# DEVELOPMENT REVIEW BOARD REPORT

CASE NUMBER/ PROJECT NAME	<b>14-DR-2006</b> <b>64<sup>th</sup> Street Reservoir Security Improvements</b>		
LOCATION	6307 E. Thomas Road		
REQUEST	Request approval of a site plan, landscape plan and wall elevations for City of Phoenix, Water Services Department security improvements for the 64 <sup>th</sup> Street Reservoir.		
OWNER	City of Phoenix 602-534-6883	ENGINEER	Stantec Consulting 602-938-2200
ARCHITECT/ DESIGNER	N/A	APPLICANT/ COORDINATOR	Tricia Cook Stantec Consulting 602-938-2200

OVERALL SITE PLAN

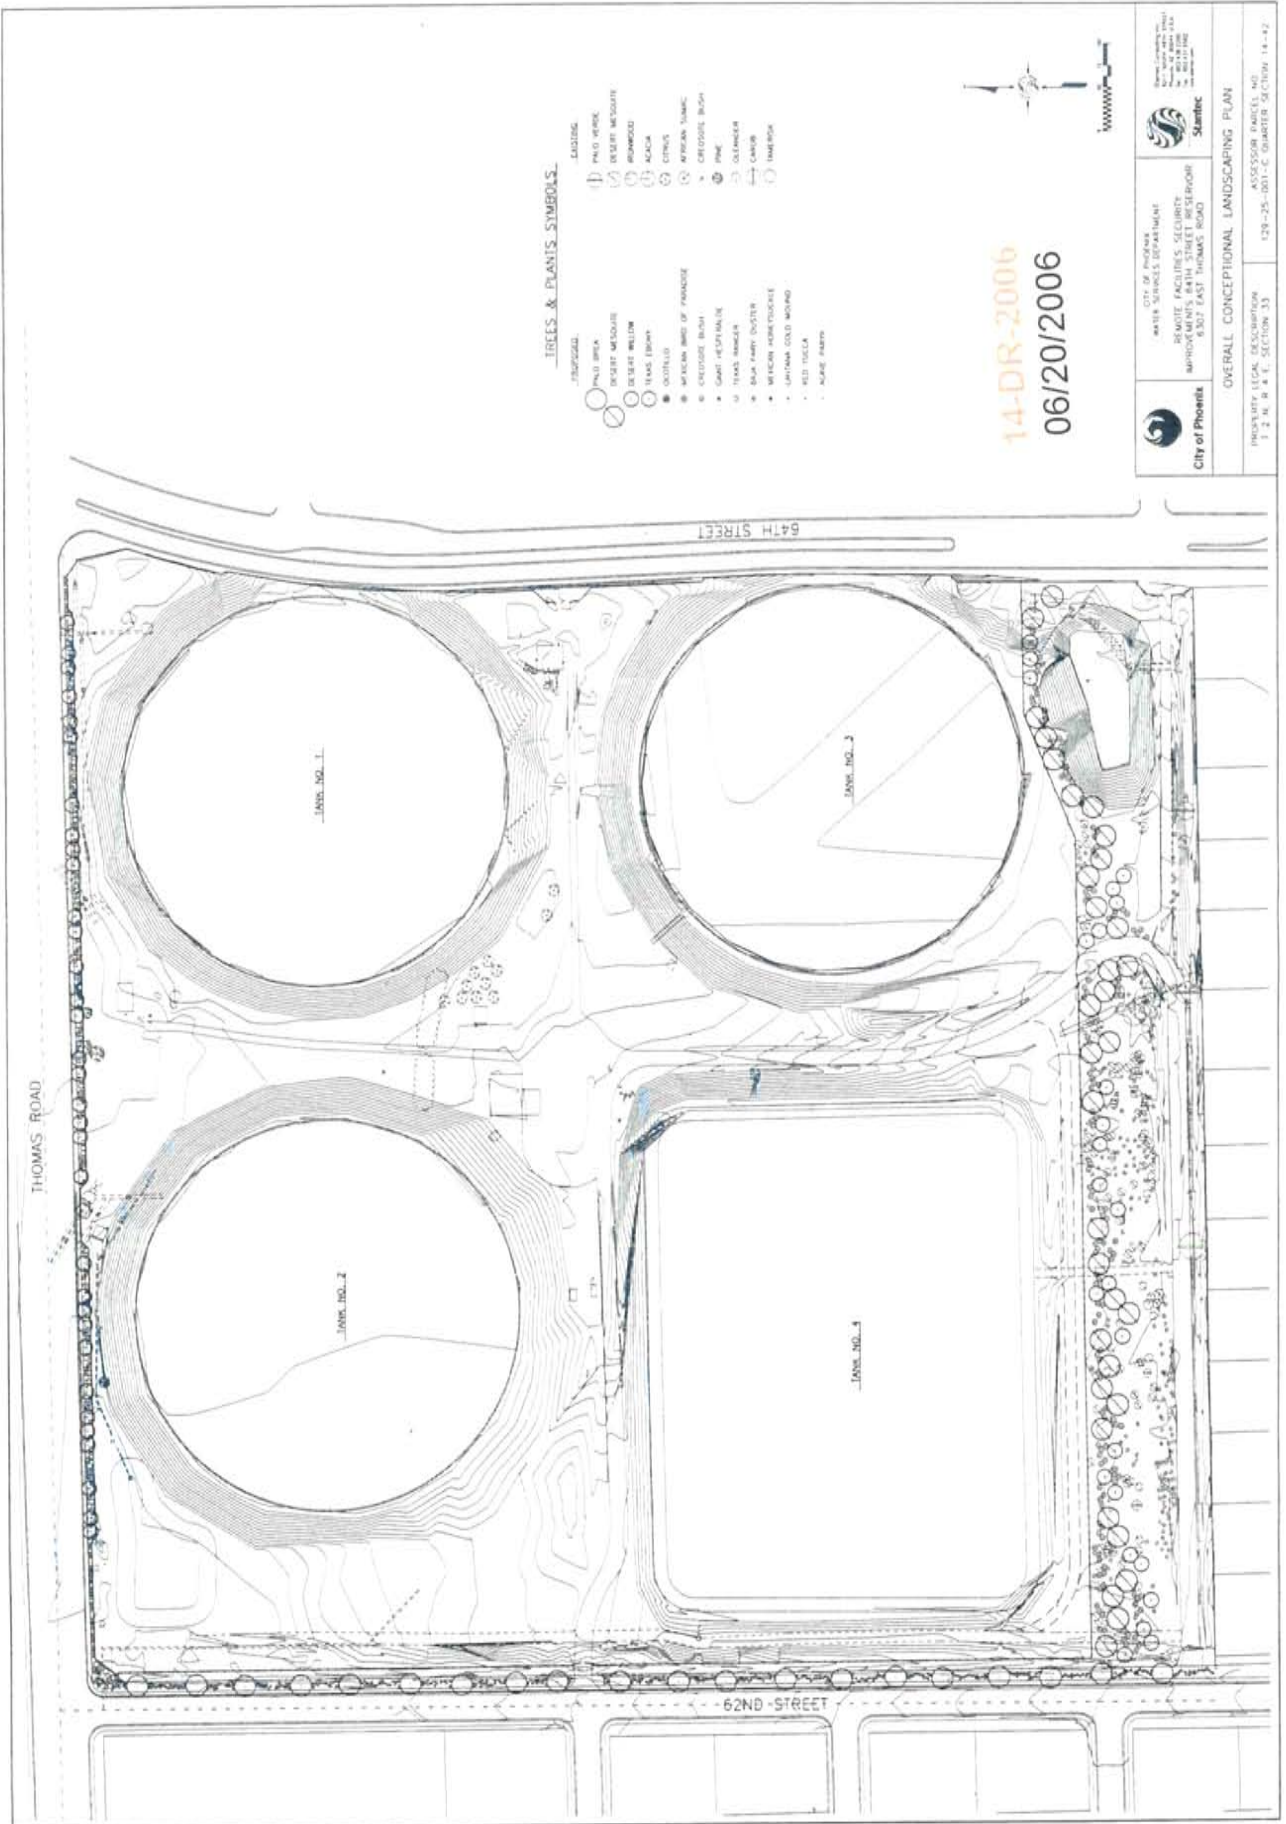
Councilwoman Drake commented in reviewing the landscape plan along the neighborhood side it appeared that trees had been placed there, she suggested a few more trees could be added to fill in the gaps.

Vice-Chairman Jones suggested that along Thomas Road there may be an opportunity to have the existing barrier that is in the middle of the block turned into the recess between the two tanks, which may add some variety. This could create a landscape area or some visual relief along Thomas Road.

CITY OF PHOENIX  
64th ST RESERVOIR SECURITY IMPROVEMENTS  
MODIFIED CHAIN-LINK FENCE

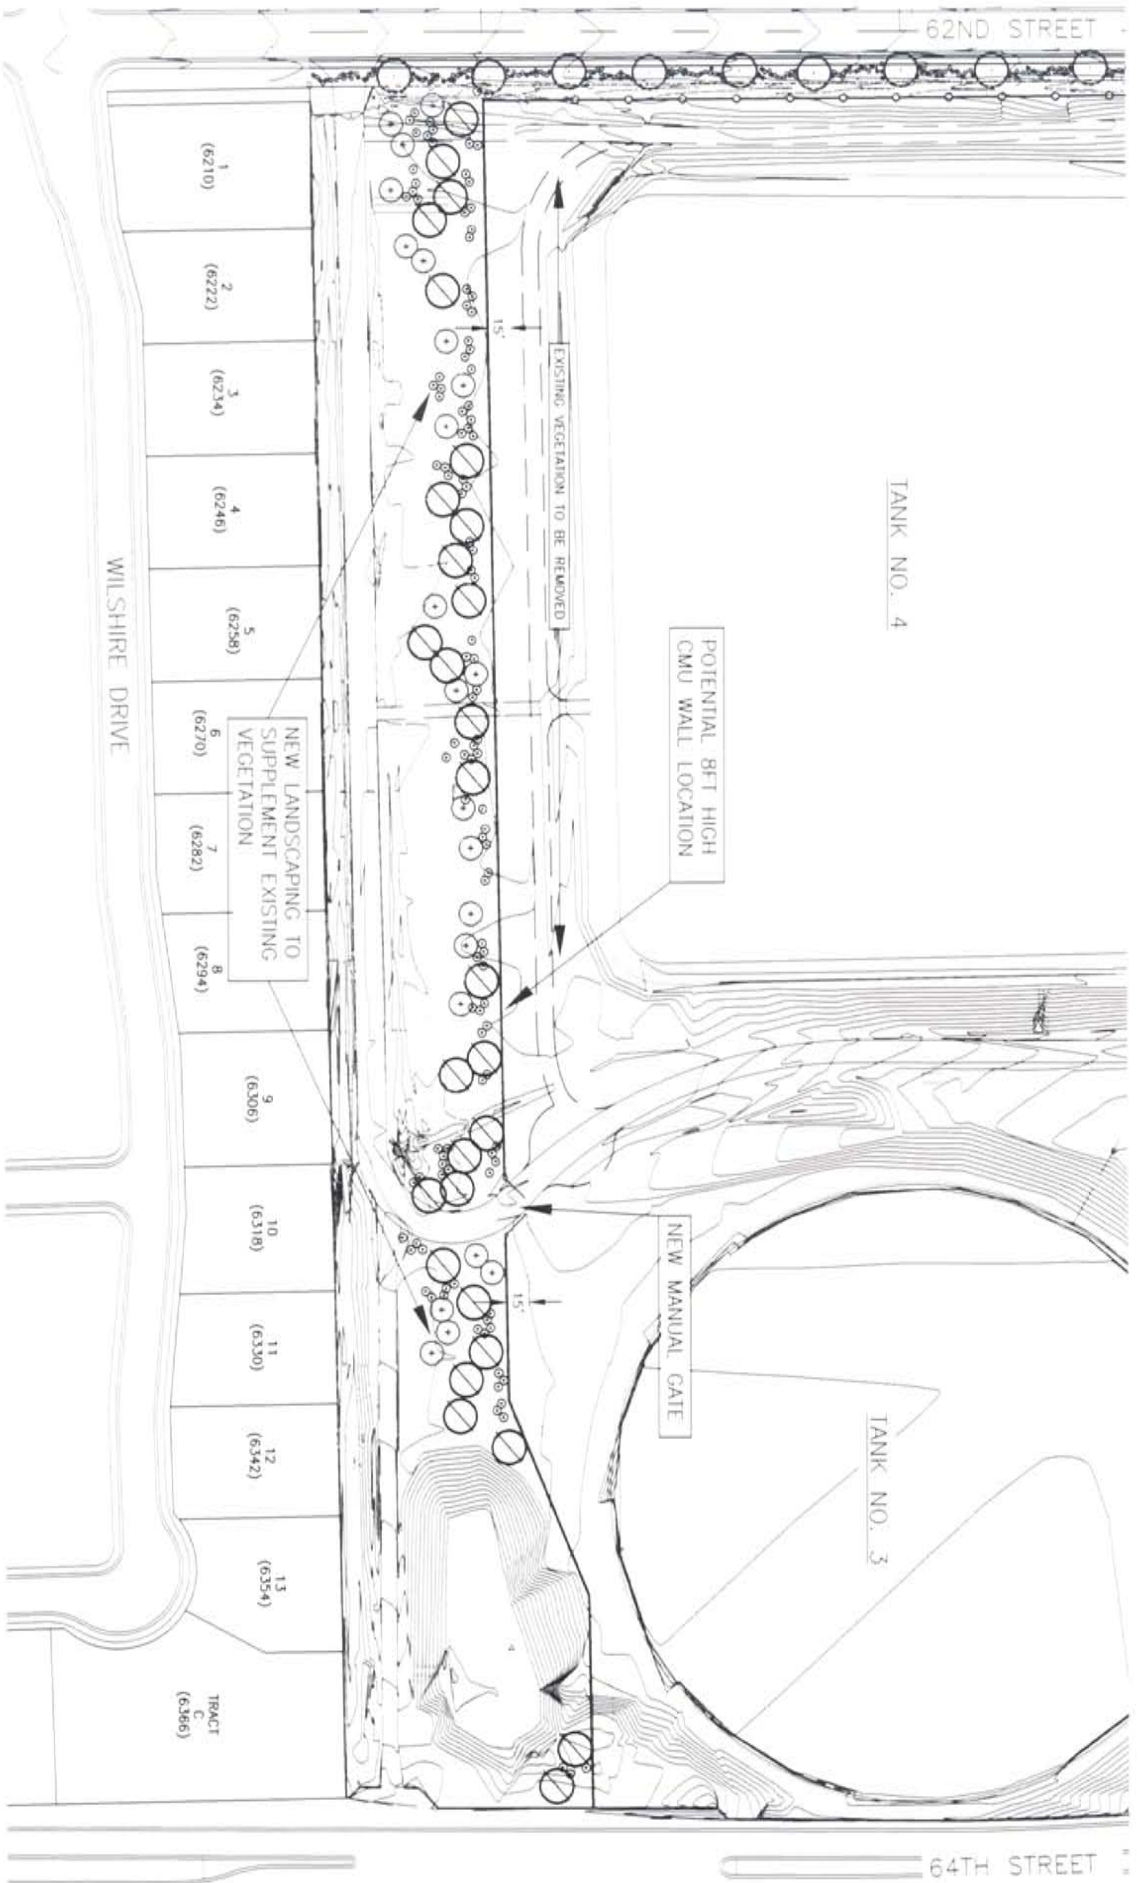
**Stipulation #9** states that: *The fence along the southern boundary of the facility shall be black wrought iron, and the access gate between tanks 3 and 4, as depicted on the site plan, shall be black wrought iron.*

Should the chain-link fence not be acceptable, the City would be agreeable to install a block (CMU) fence. However, if this fence were to be installed, it would be necessary to install it 15 feet closer to the south property line to provide room for the installation of additional security equipment inside the fence. The impact of moving the fence closer to the property line is increased visibility and no space at the retention basin to install landscape screening. It is also not possible to adjust the location of the fence between tanks 3 and 4, as discussed in the option above, so the fence may be visible near the access road as well as the retention basin. Enclosed is a sketch showing this option.

We request that the Development Review Board delete this stipulation and accept the proposed design for a vinyl coated chain link fence to secure the south boundary of the site. We believe that this option will provide the highest level of site security, while having the least impact to the neighboring residents.
